Access Compliance Report

Public Rights-of-Way

Intersection ID: 52996	Main Street: TIMBERBROOK_DR	Cross Street: VICTORIA_BROOK_LN	Location: SE
ADA ID: 1255B2280D92	Ramp Type: PerpDiag	Initial Pass/Fail: Fail	Overall Compliance: No
Codes/Mitigation Info/Possible Solution		Field Measurements/Component Compliance	
Severity Score: 21.25

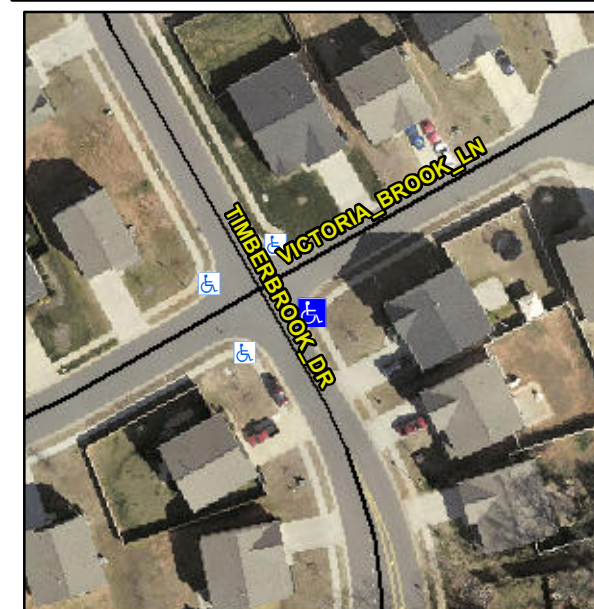
Not Found, R304.5.1, R304.2.2

Compliance	Description	Data	Compliance	Description	Data
N/A	Ramp Length (in)	48.0	No	Ramp Slope (%)	9.8
No	Ramp Width (in)	47.5	Yes	Ramp XSlope (%)	0.9
N/A	Flare Type LT	N/A	N/A	Flare Type RT	N/A
N/A	Flare Slope LT (%)	N/A	N/A	Flare Slope RT (%)	N/A
N/A	Flare Traversable LT?	N/A	N/A	Flare Traversable RT?	N/A
N/A	Landing Length (in)	N/A	N/A	DWS Provided?	N/A
N/A	Landing Width (in)	N/A	N/A	DWS Contrast?	N/A
N/A	Landing Slope (%)	N/A	N/A	DWS Length (in)	N/A
N/A	Landing X Slope (%)	N/A	N/A	DWS Full Width?	N/A
N/A	Landing Curb? (Y/N)	N/A	N/A	DWS Offset (in)	N/A
N/A	Shared Landing?	N/A			
N/A	Gutter Ponding?	N/A	N/A	Gutter Slope (%)	N/A
N/A	Gutter Lip Ht (in)	N/A	N/A	Gutter X Slope (%)	N/A
N/A	Painted X Walk1?	No	N/A	Painted X Walk2?	No
	X Walk 1 Direction	To N		X Walk 2 Direction	To W
N/A	X Walk 1 Width (in)	N/A	N/A	X Walk 2 Width (in)	N/A
	X Walk 1 Slope (%)	2.2		X Walk 2 Slope (%)	0.5
	X Walk 1 X Slope (%)	1.4		X Walk 2 X Slope (%)	2.3

Remove & Replace Curb Ramp With Two New Directional Ramps or Equivalent.
